Addendum to the City of Markham Committee of Adjustment

File: A/171/17
Address: 11 Fredericton Road, Markham
Applicant: Anna Maria Sgouros & Nichoals Steve Kalantzis
Agent: SDG Design (Stefano Di Giulio)
Hearing Date: Wednesday February 21, 2018

Memorandum to the City of Markham Committee of Adjustment

**Re: Variance Application - A/171/17
11 Fredericton Road, Markham, ON
Anna Maria Sgouros & Nicholas Steve Kalantzis (Owner)
Stefano Di Guilio (Agent)**

SITE PLAN WITH PROPOSED NEW CUSTOM HOME

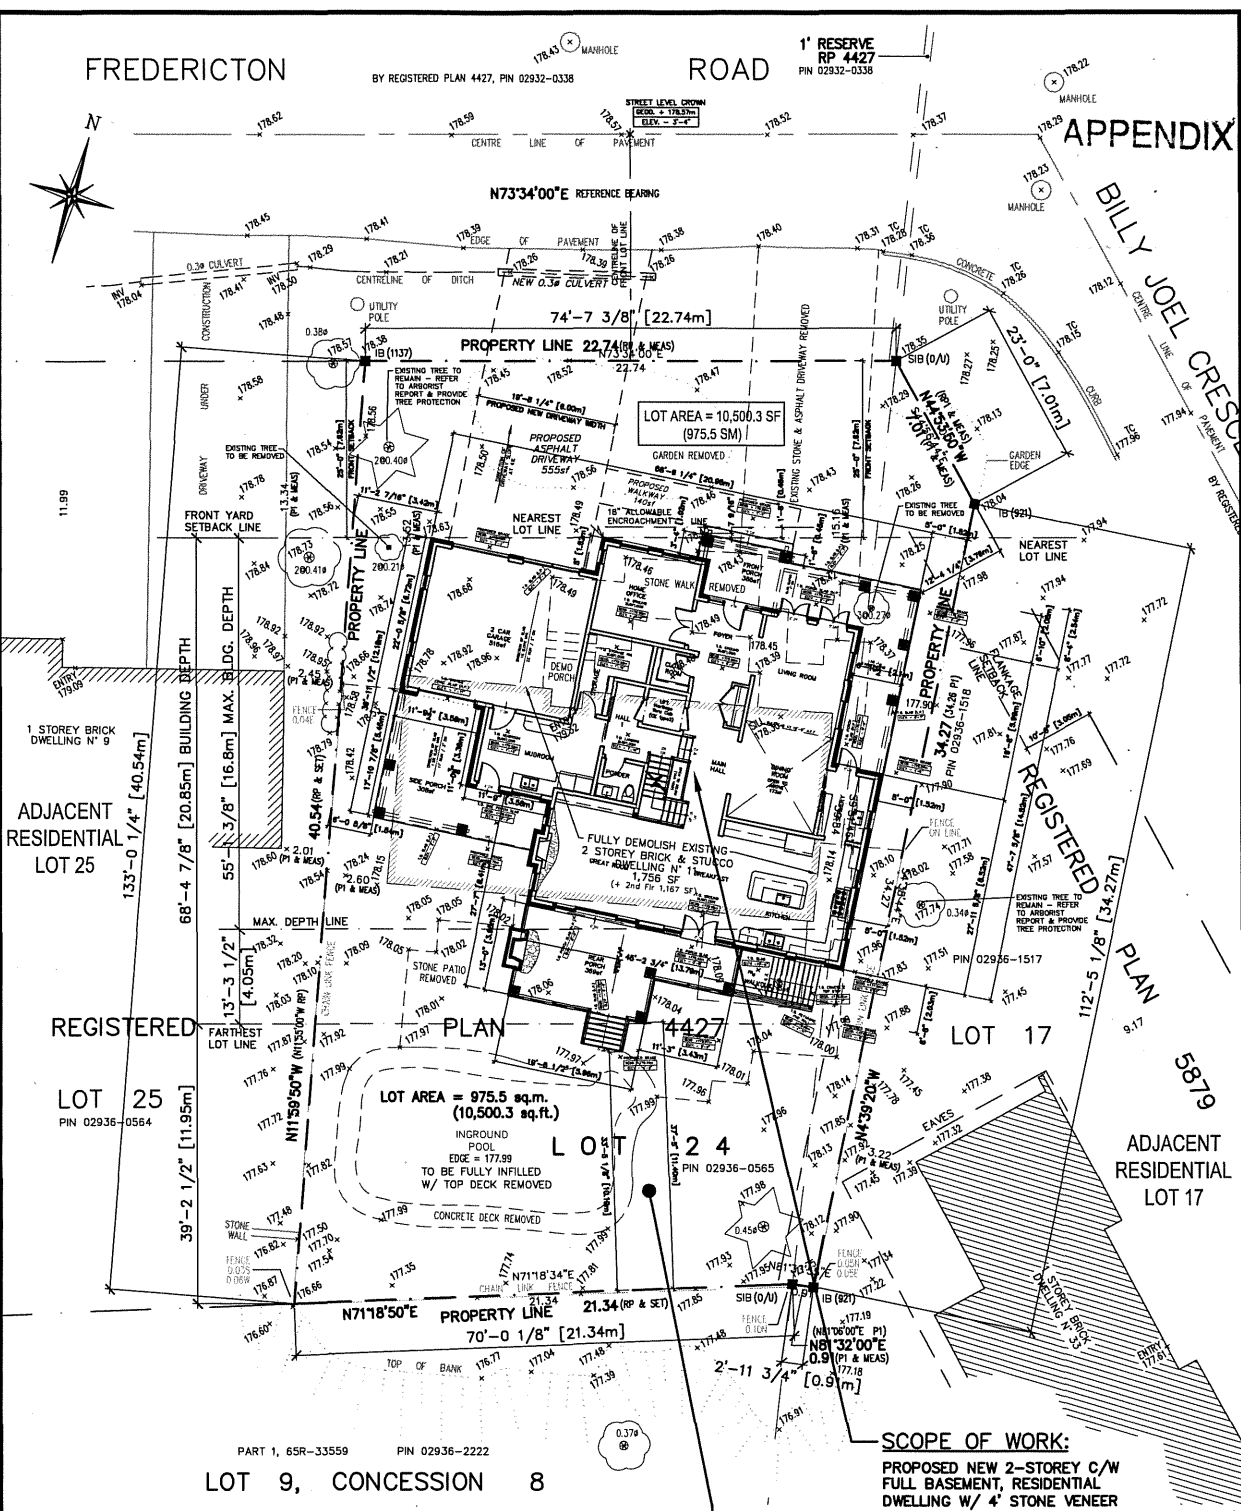
The applicant is requesting relief to permit a maximum lot coverage of 35.46 percent, whereas the By-law permits a maximum lot coverage of 35 percent. Staff are of the opinion that the proposed lot coverage represents a modest increase from the by-law.

3,723 SQ.FT. OF DWELLING AREA DIVIDED BY 10,500.3 SQ.FT. OF ACTUAL LOT AREA = 35.46% LOT COVERAGE IS GREATER THAN THE R1 DESIGNATION OF ZONING BY-LAW 1229 REQUIREMENTS OF THE MAX. LOT COVERAGE OF 35%. **NOTE: MINOR VARIANCE - REQUIRE RELIEF OF 0.46% (48 SQ.FT.) OF ADDED LOT COVERAGE.**
